# PROGRAM BULLETIN

04067

REPLACEMENT OF REAR LATERAL LINK ASSEMBLIES

2002-2004 SATURN VUE VEHICLES

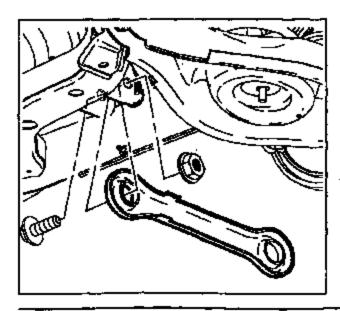
Position the NEW lateral link assembly (toe link, P/N 15248161) to the knuckle. Install NEW lateral link assembly-to-knuckle bolt (P/N 11518701) and NEW nut (P/N 11516382). Hand tighten only.

- Position lateral link assembly to support assembly. Install NEW lateral link assembly-tosupport assembly bolt (P/N 22639398) and NEW cam nut (P/N 11519455). Hand tighten only.
- Tighten the lateral link assembly-to-support assembly bolt and carn nut.

Tighten bolt to 145 N·m (107 lb-ft).

## Wheel Alignment Specifications

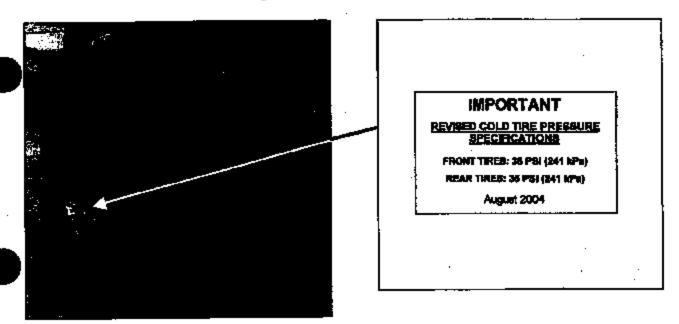
**EMPORTANT:** When measuring alignment angles, it is critical that vehicle bumper heights are within specifications (front:  $410 \text{ mm} \pm 25 \text{ mm}$  [ $16.14 \text{ in} \pm 0.98 \text{ in}$ ); rear:  $435 \text{ mm} \pm 25 \text{ mm}$  [ $17.13 \text{ in} \pm 0.98 \text{ in}$ ], measured from lower edge of bumper). If not correct, add or remove weight until bumper height is correct.

- 8. Perform rear alignment.
  - 8.1 Adjust tire pressure to NEW specifications:
    - Front Tires: 35 psi (241 kPa)
    - Rear Tires: 35 psi (241 kPa)
  - 8.2 Install the alignment equipment according to the manufacturer's instructions.
  - 8.3 Jounce the front and the rear bumpers three times prior to checking the wheel alignment.
  - 8.4 Measure the alignment angles and record the readings.
  - 8.5 Adjust alignment angles to vehicle specification, if necessary. Refer to Wheel Alignment Specifications table. Adjust angles in the following order: (1<sup>st</sup>) rear toe; (2<sup>st</sup>) rear camber.
- After performing rear alignment, with the steering wheel still locked in the center position, check the
  front toe and adjust if necessary. Front total toe specification: 0.15° ± 0.15°.
